PROJECT **123A90 - HOLLANDSE KUST NOORD WIND PARK**
BLPH Project

MECHANICAL COMPLETION DOSSIER (ONSHORE)

SYSTEM	70 Safety and Facility Systems
SUBSYSTEM	70-00-06 Junction Box 950-JE-02103 and Multi-core cable (FGS System)

C30002033

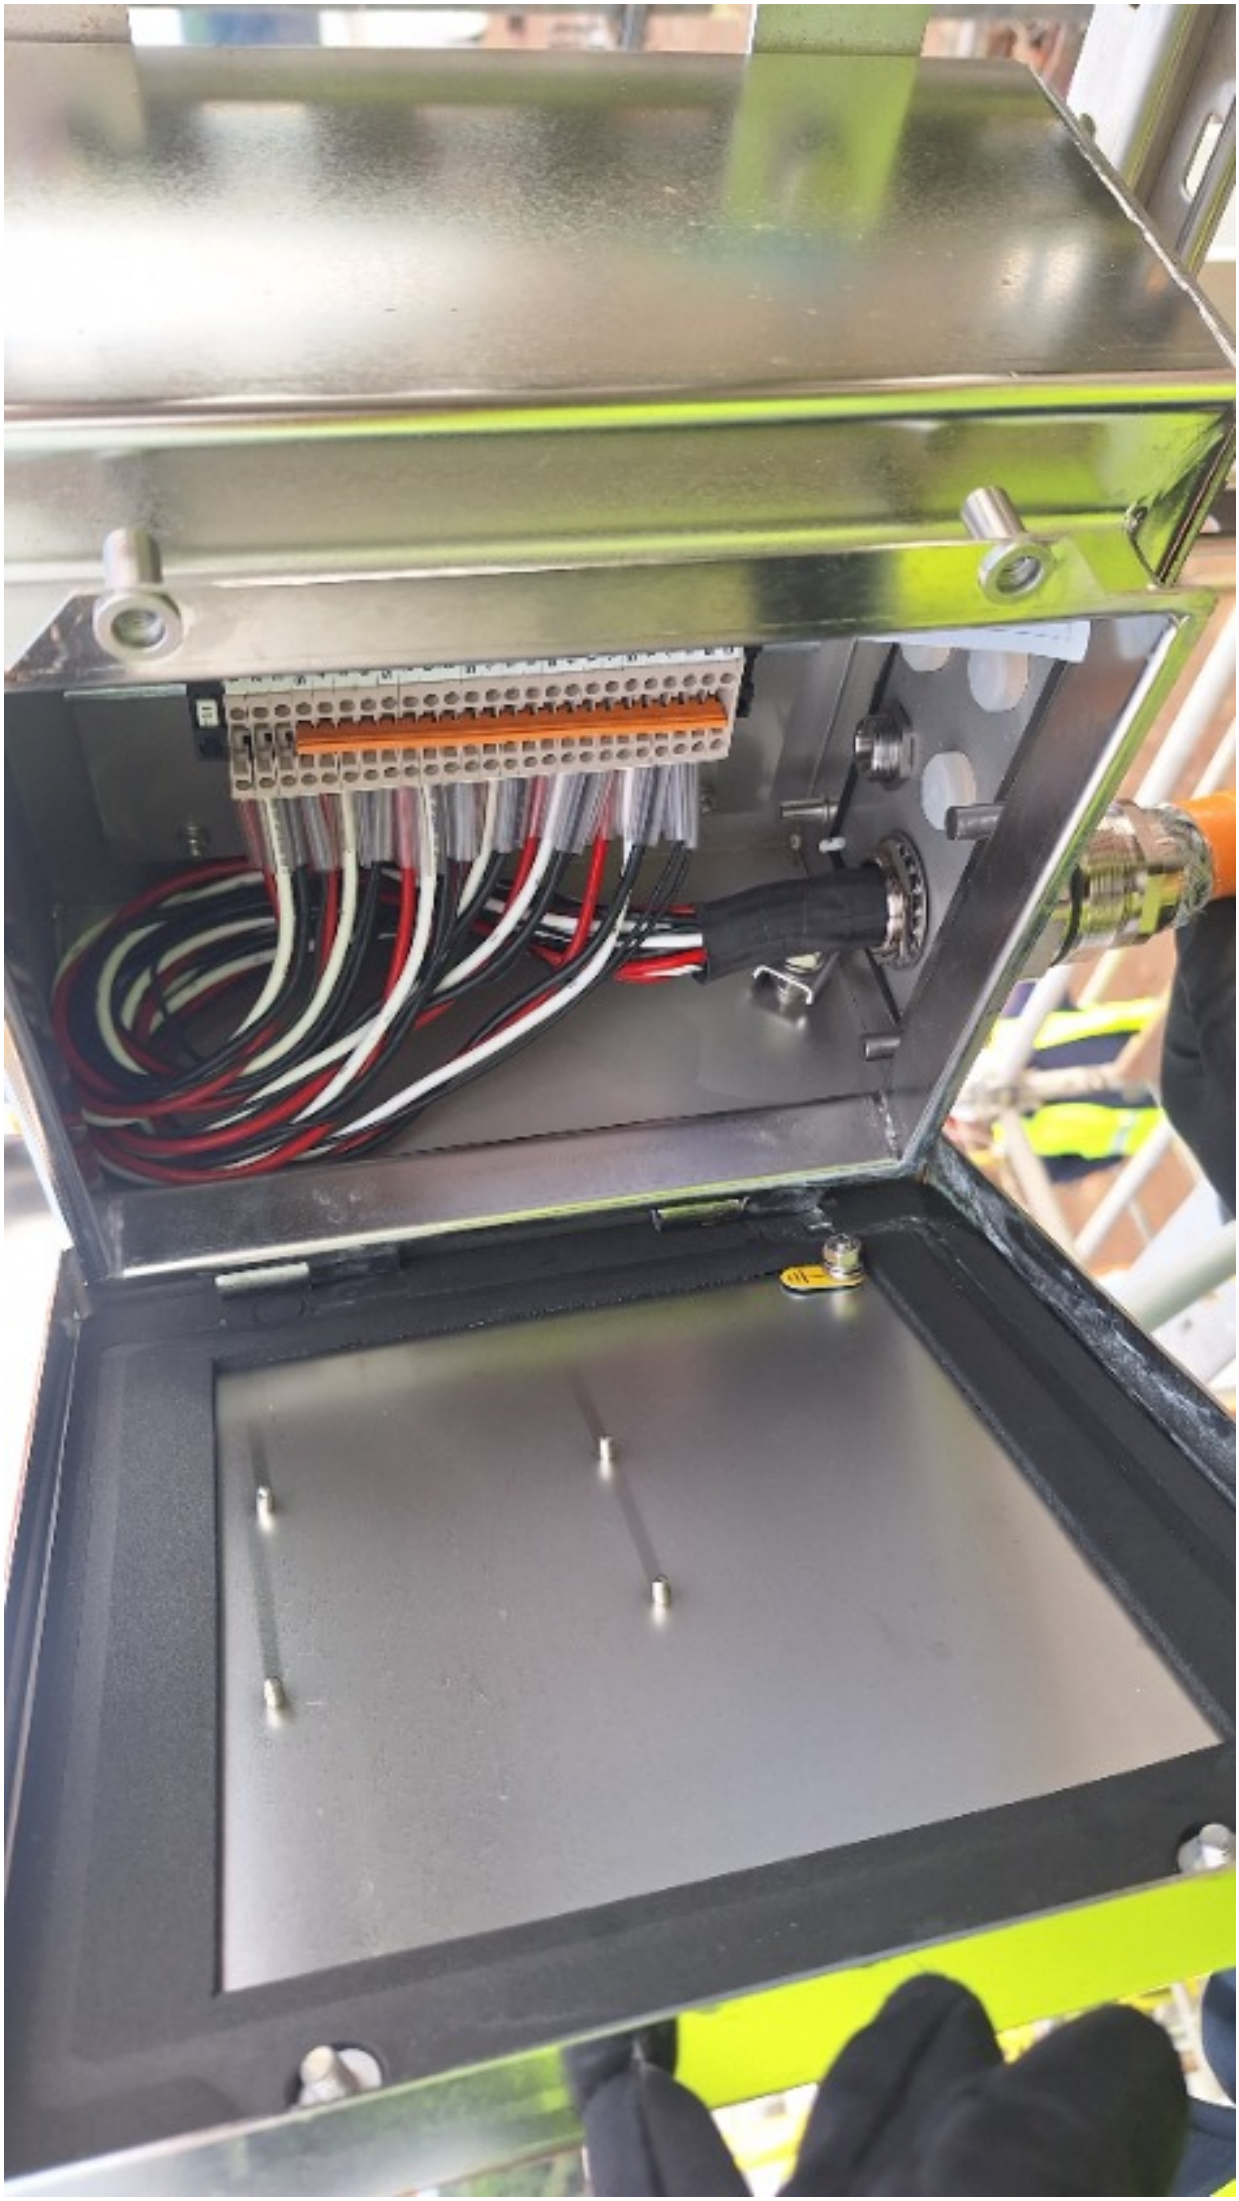
The rivets, inside the cover, must be "sealed" with suitable material.

Vendor declare that rivets used by Cortem to fix the tags on the cover of the
junction boxes series CTB have been tested and certificated to guarantee the degree
of protection of IP66.

C30002027

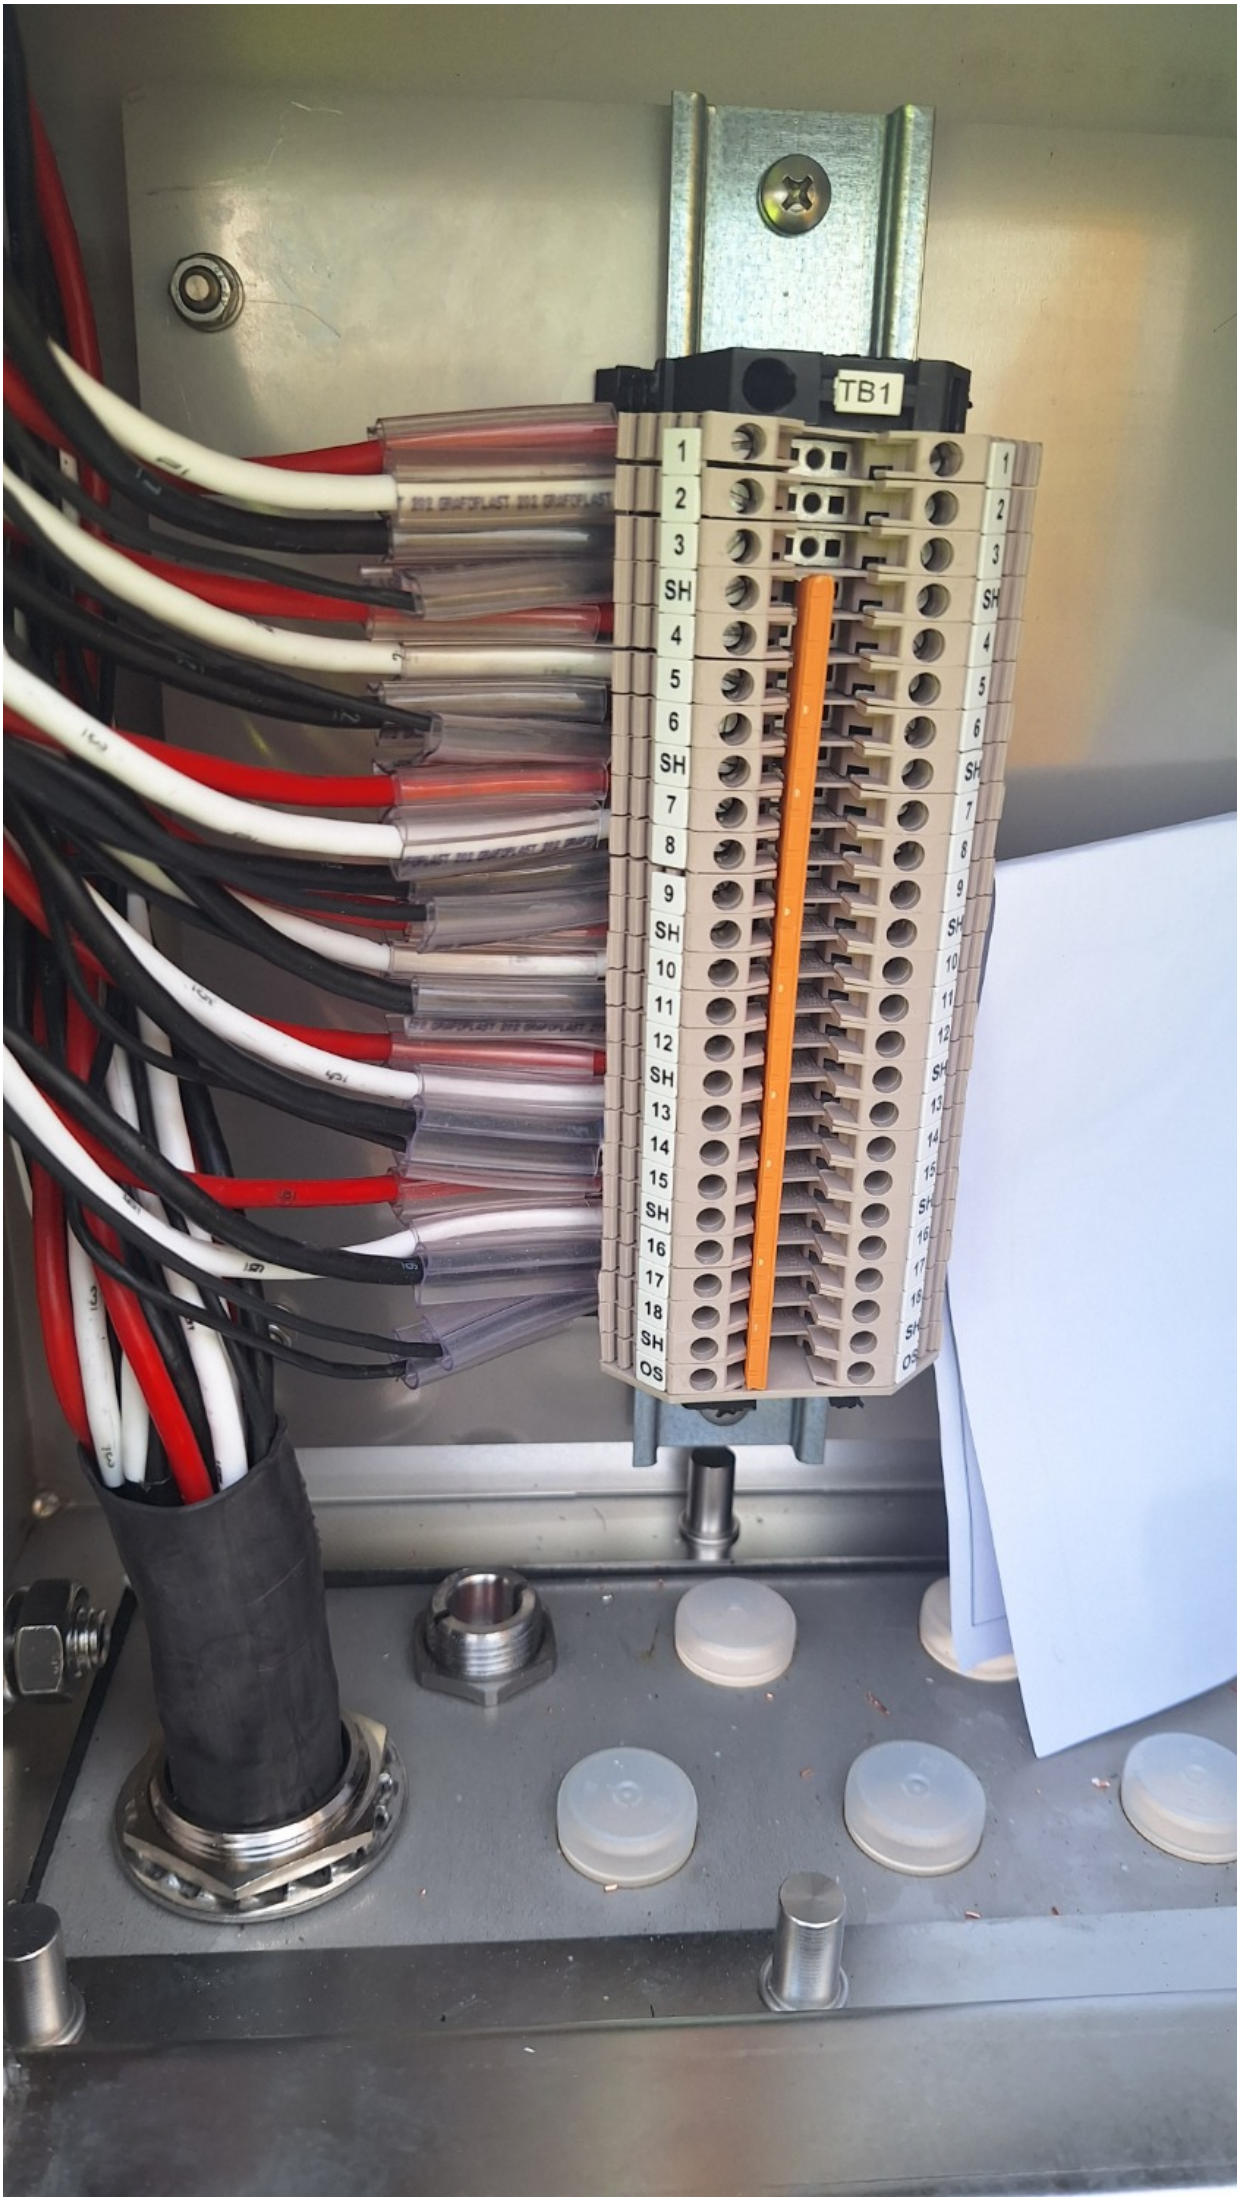
Missing cores identification tag. side 950-JE-02103 . (see document 123A90-DDL-IN-DG-40016 sh.3)

DONE

C30002032

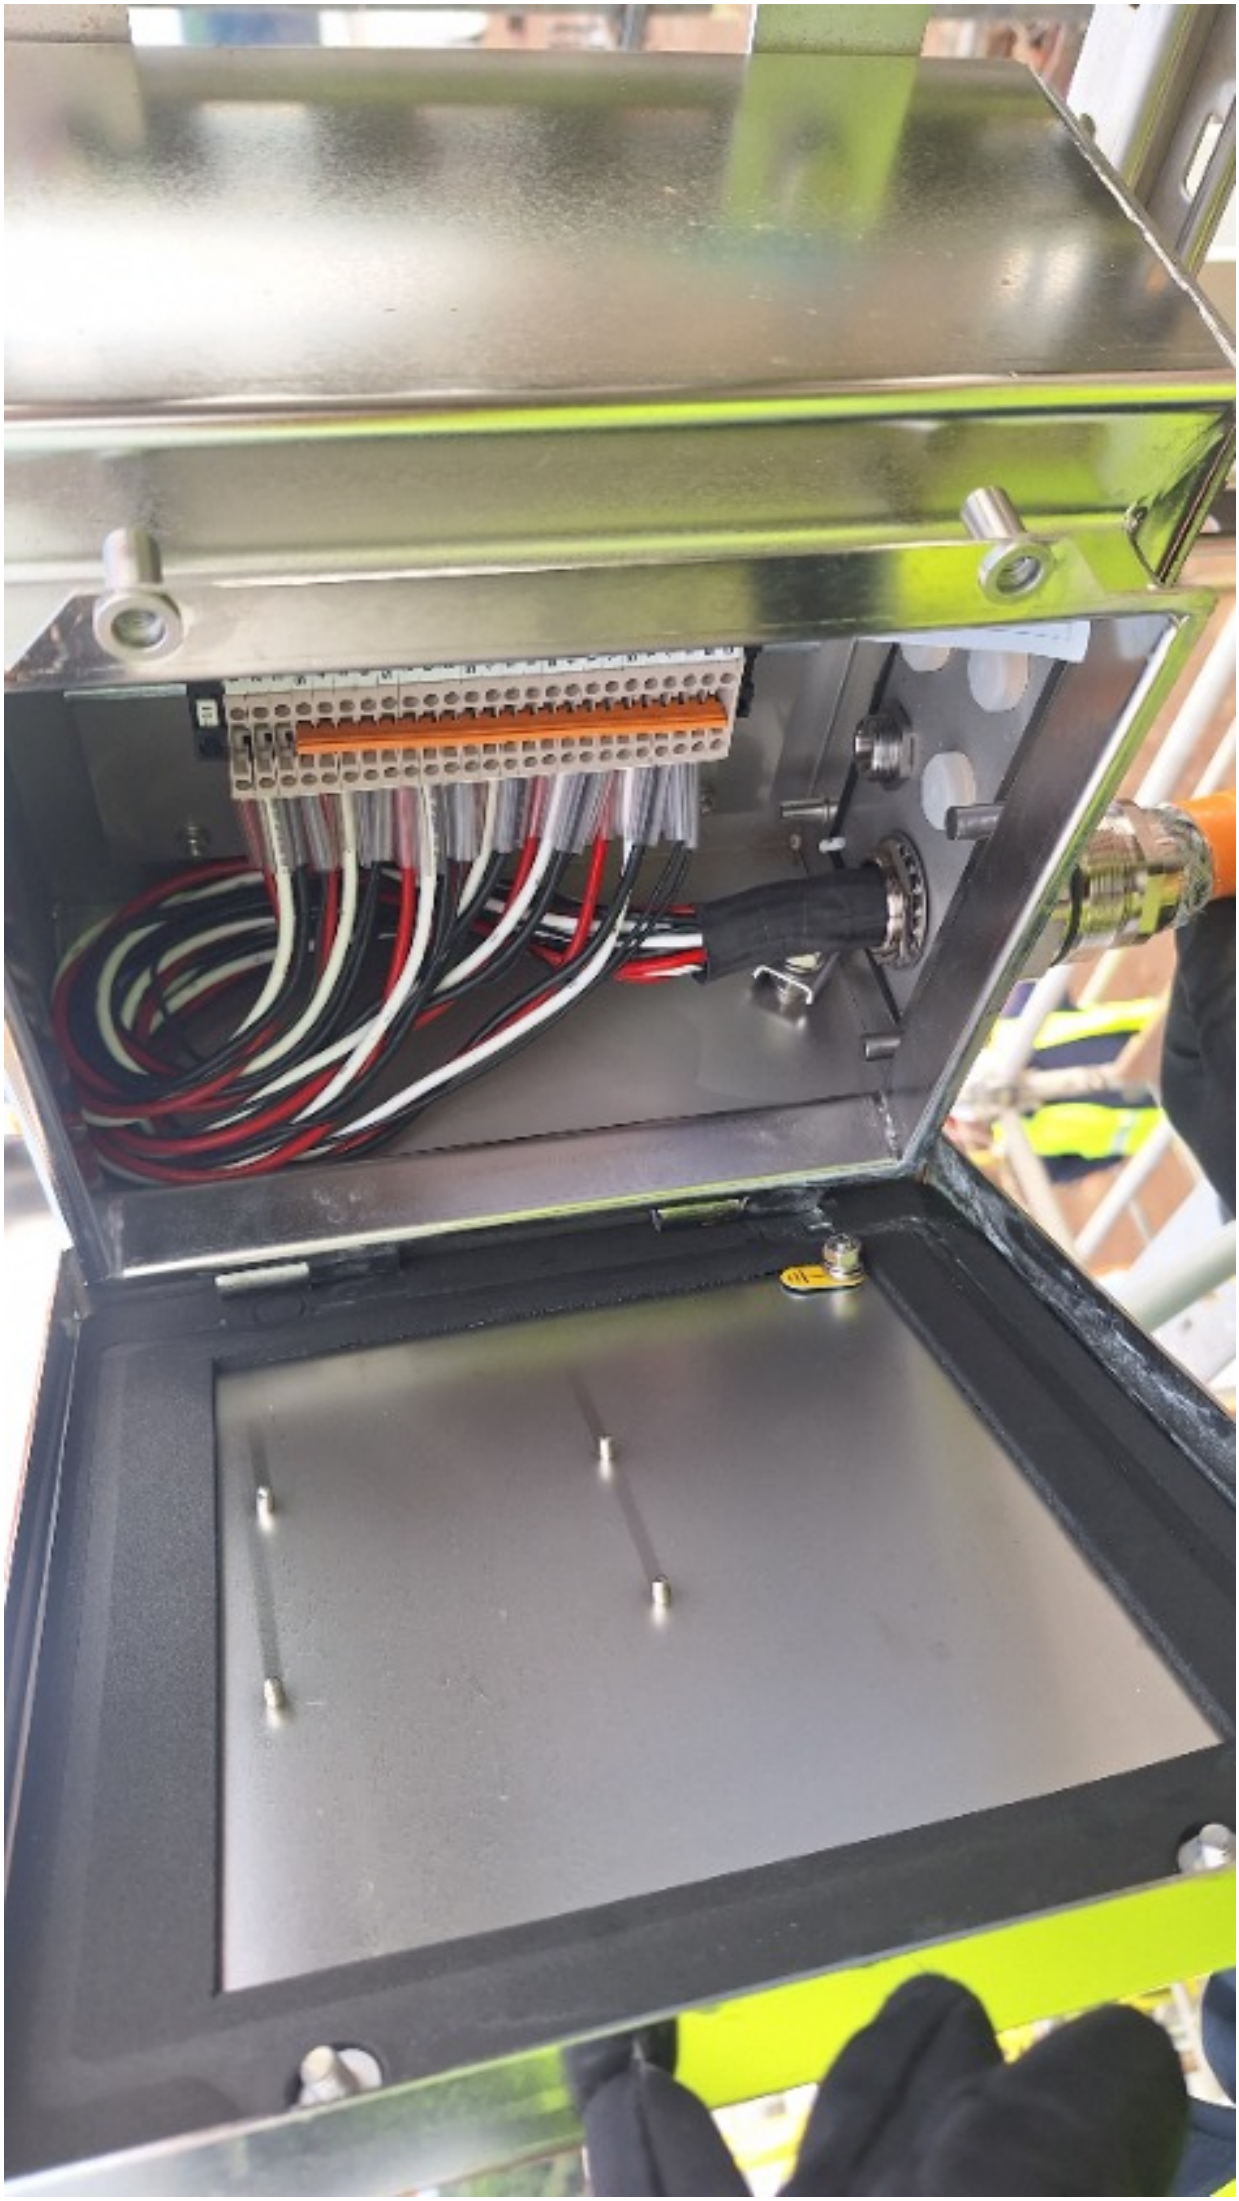
Missing the earth cable inside between jb and cover.

DONE
